Commonwealth Edison Company  
Byron/Braidwood Units 1 and 2  
Relaxation of MSSV Setpoint Tolerance to +/-3% - Revised SECL

Enclosed please find Revision 1 to safety evaluation SECL 90-469, previously transmitted via Reference 1. The revised safety evaluation clarifies the section of the ASME code associated with the main steam safety valves.

WESTINGHOUSE NUCLEAR SAFETY  
SAFETY EVALUATION CHECK LIST

APPENDIX B  
UFSAR MARKUPS

FIGURE 15.2-2

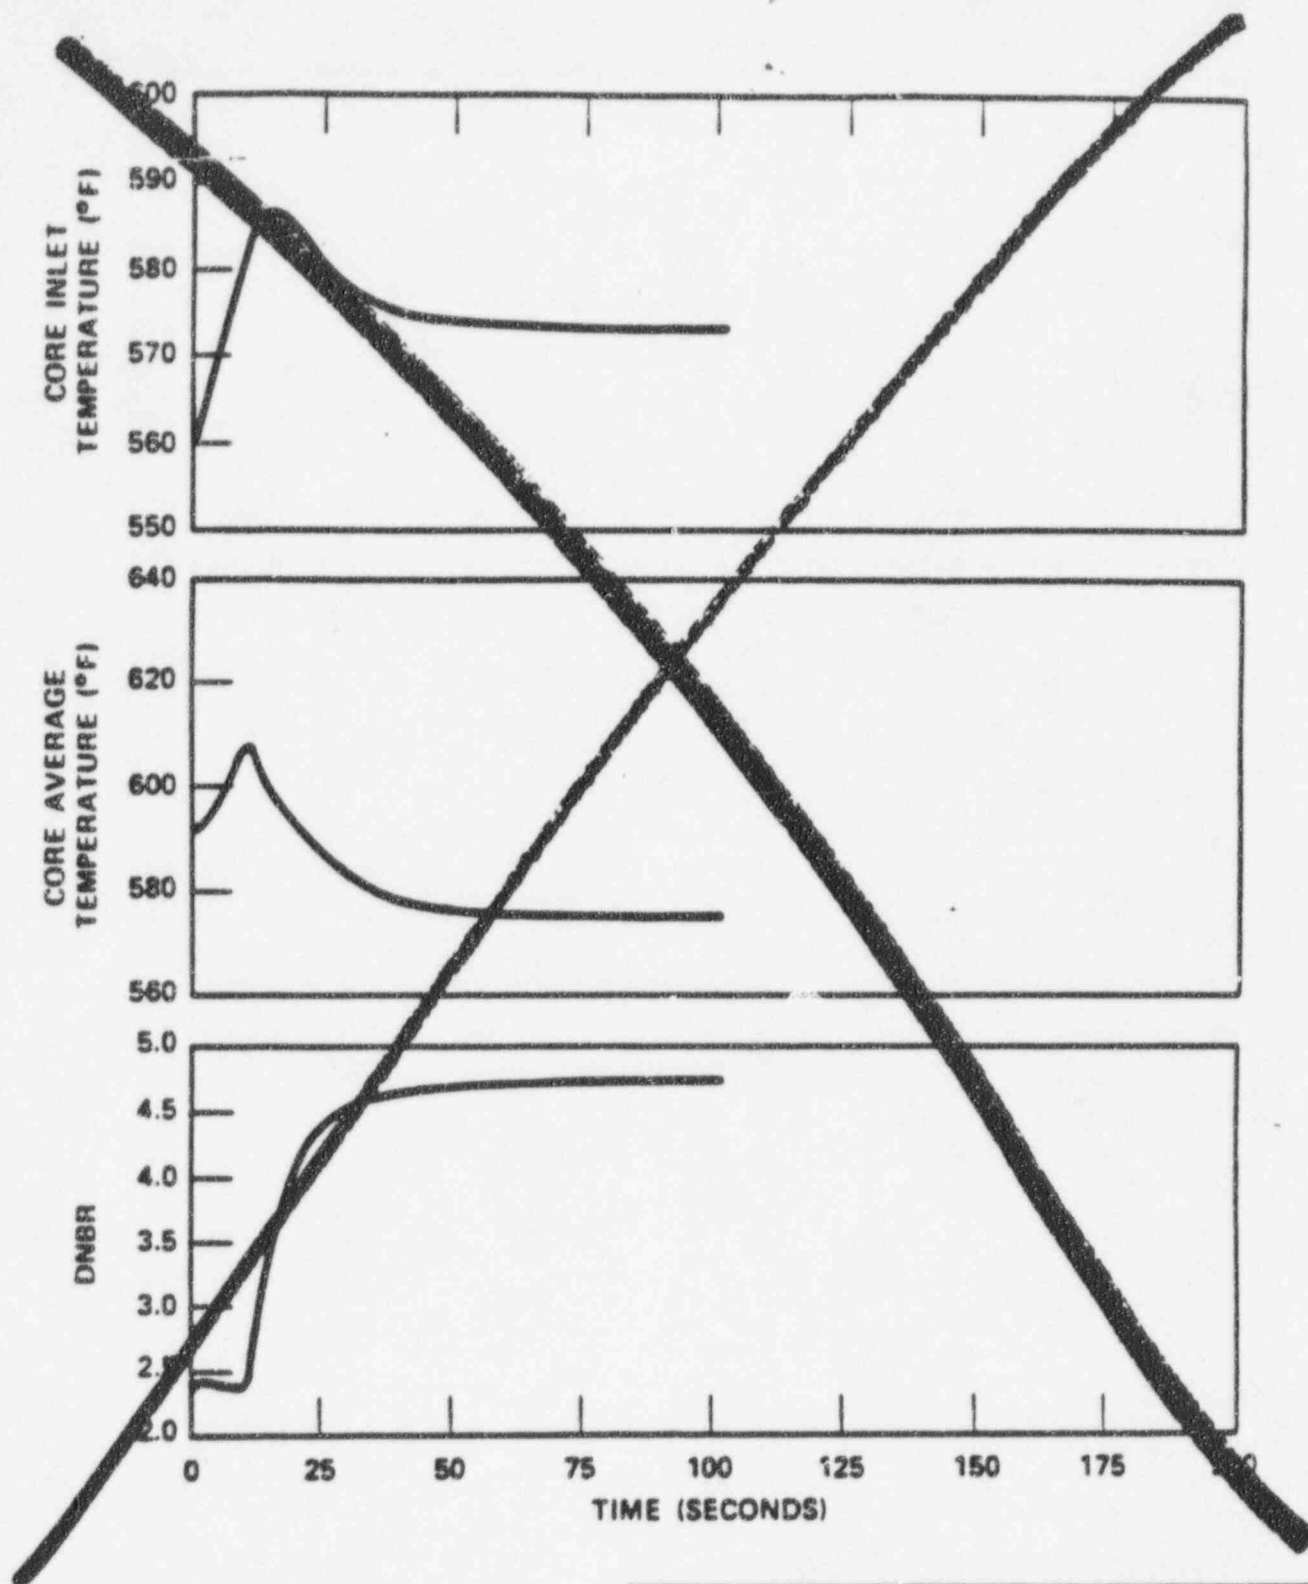
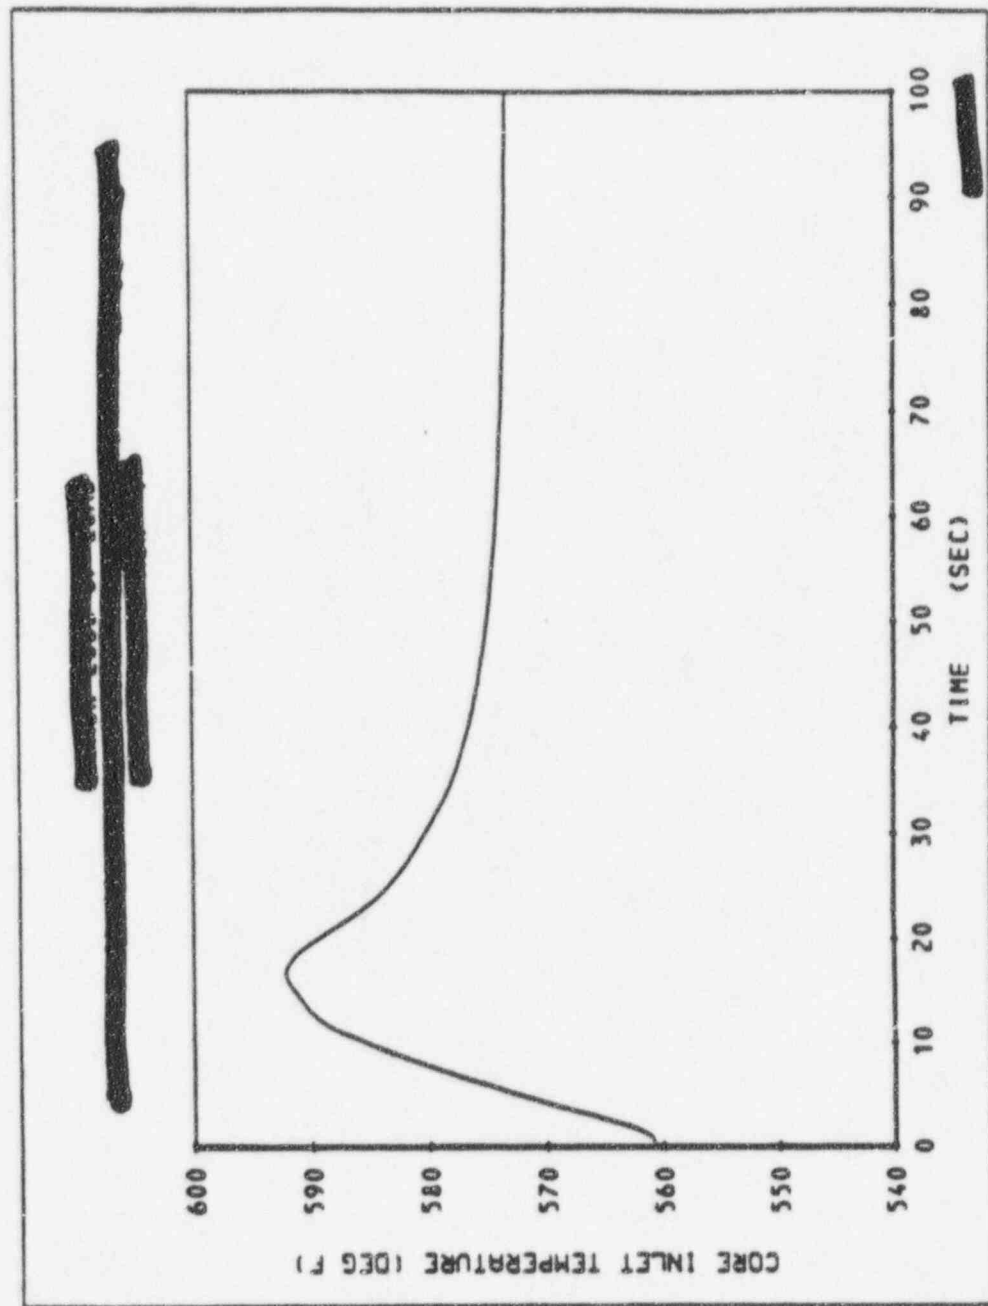
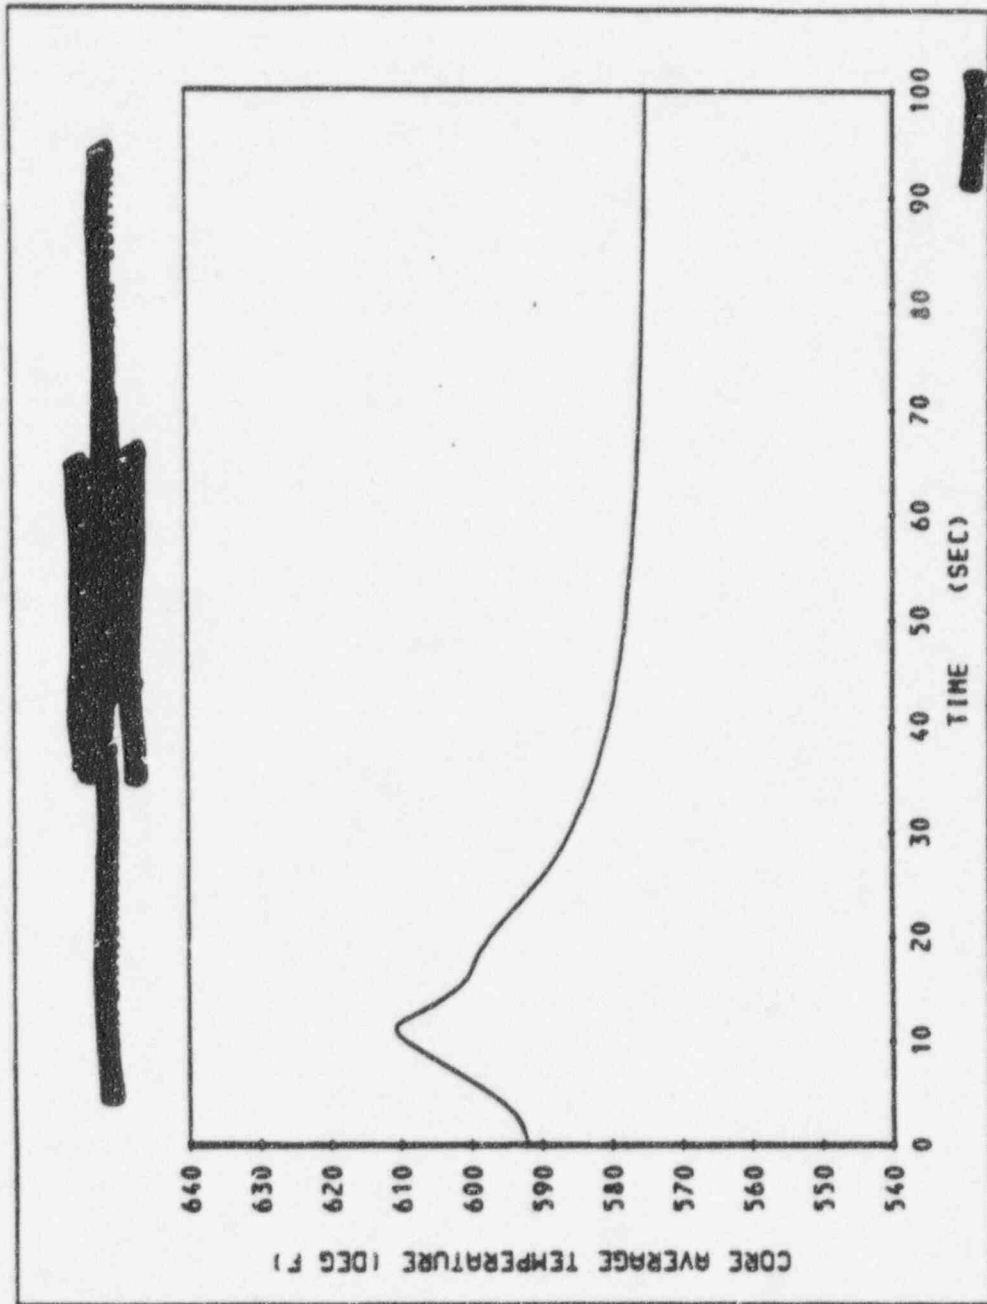
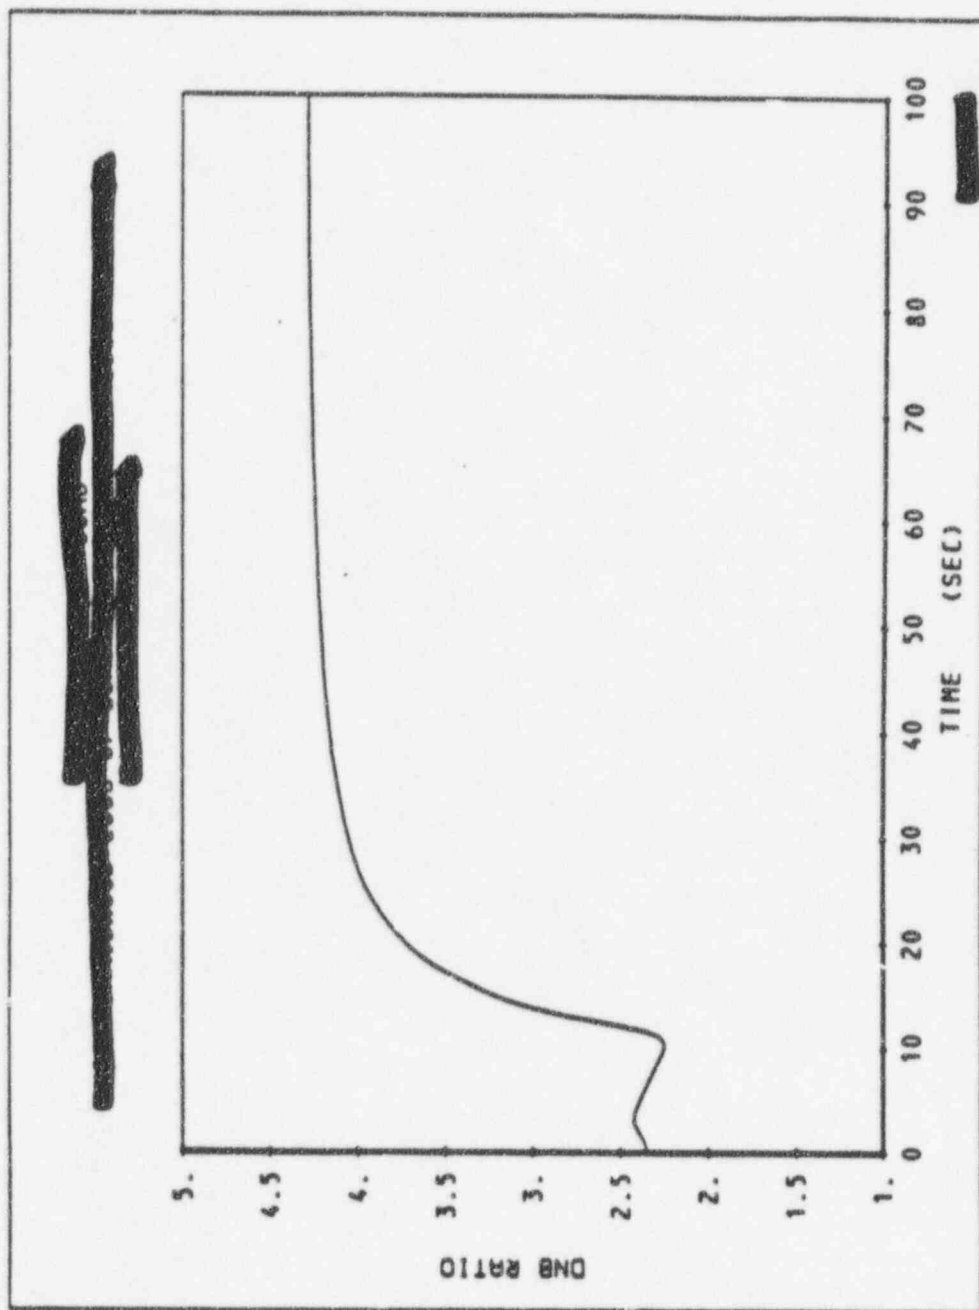
Figures 15.2-1 and 15.2-2 show the transient responses for the total loss of steam load with a least negative moderator temperature coefficient assuming full credit for the pressurizer spray and pressurizer power-operated relief valves. No credit is taken for the steam dump. The reactor is tripped by the ~~high-pressurizer pressure~~ trip channel. The minimum DNBR remains well above the limit value. The pressurizer ~~safety valves~~ are actuated and the primary system pressure remains below the 110% design value. The steam generator safety valves limit the secondary steam ~~conditions to saturation at the safety valve setpoint.~~ pressure to less than 110% of the design value.

REPLACE WITH  
The following  
Figures
